Certificate of Appropriateness

1921 N. 2ND ST.

Brewers Hill Historic District

PTS ID 112042 COA Rehab Exterior

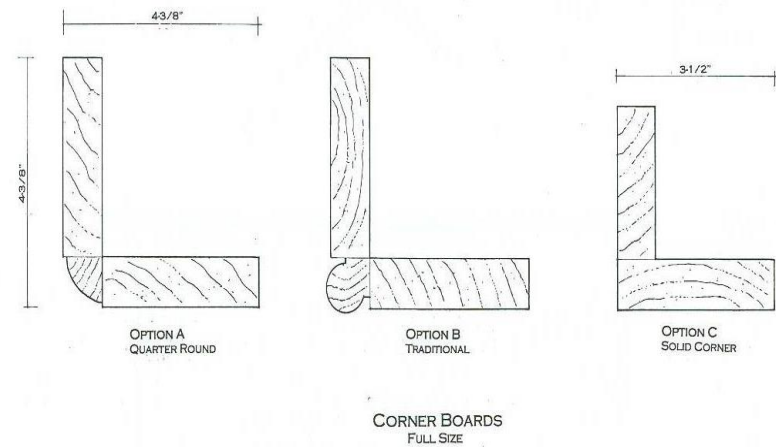
The front door with transom was original until the 1980s and has been replaced. It is the intent to install a new wood door. The door will match this original and the transom will be retained.

House as it appears today.
Window tops will match the
design as shown above.

5) The new front door will match the original as shown attached.

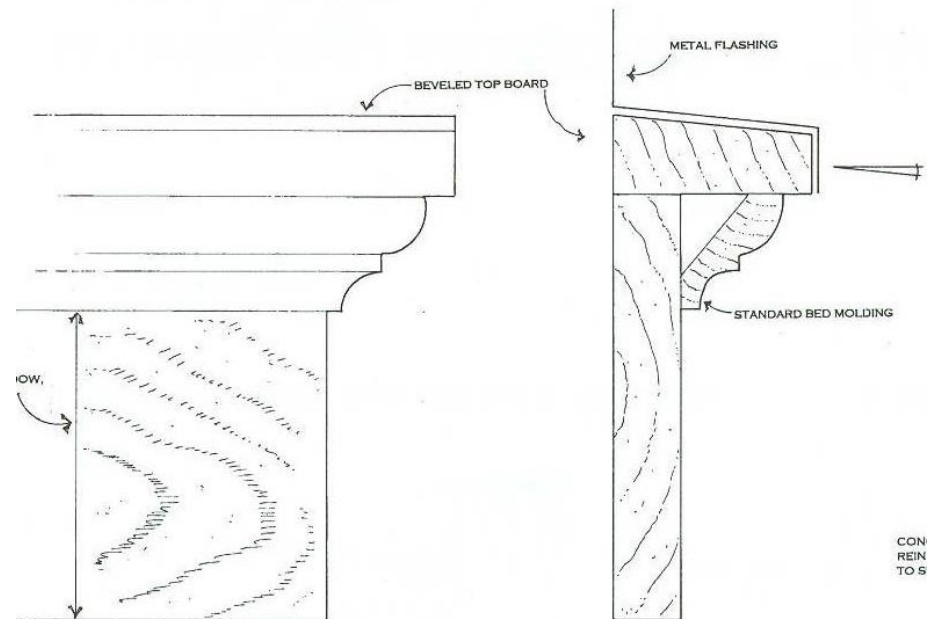
Clapboards will be replaced with new cedar siding. Corner boards can be built according to one of the designs below.

Note 2-over-2 sash. Window tops should be crowned with moldings that will shed water as shown below.

3) New wood sash windows will be installed. The windows at the lower front feature arched one-over-one sash. Side windows feature rectangular 2-over-two sash. They will match the dimensions of the originals and fit the openings. Windows at the upper front feature gabled pediments and will be retained but returned to historic character.

WINDOW AND DOOR TOPS
FULL SIZE

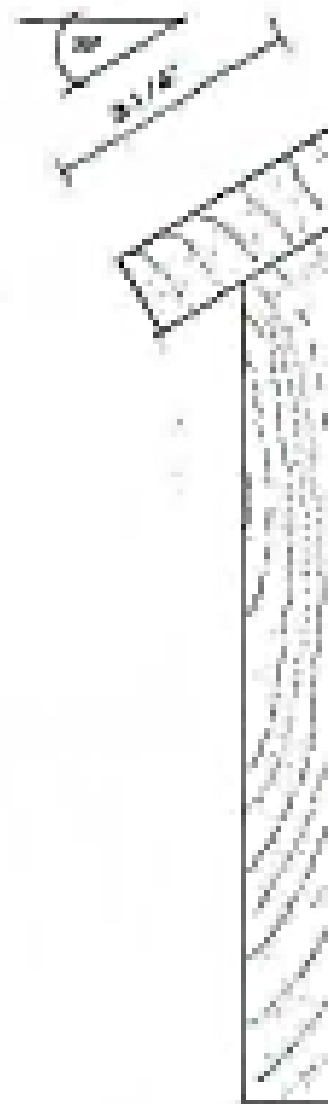
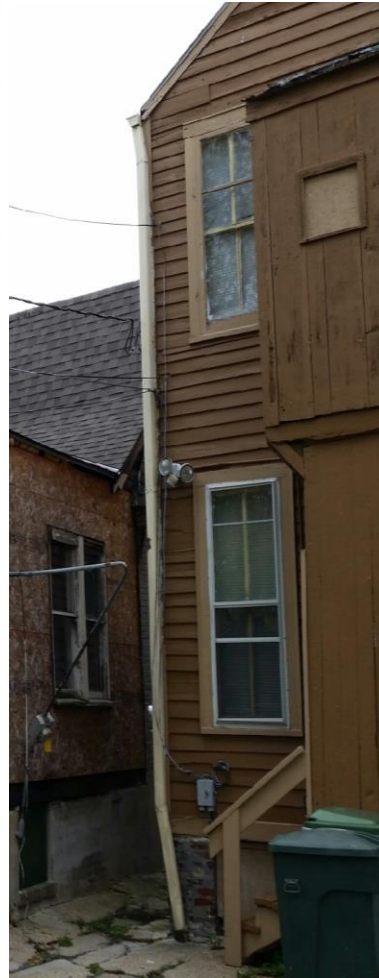
Water table will be added to help shed water

6) It appears that the water table has been removed in prior remodelings. It should be reconstructed as shown attached.
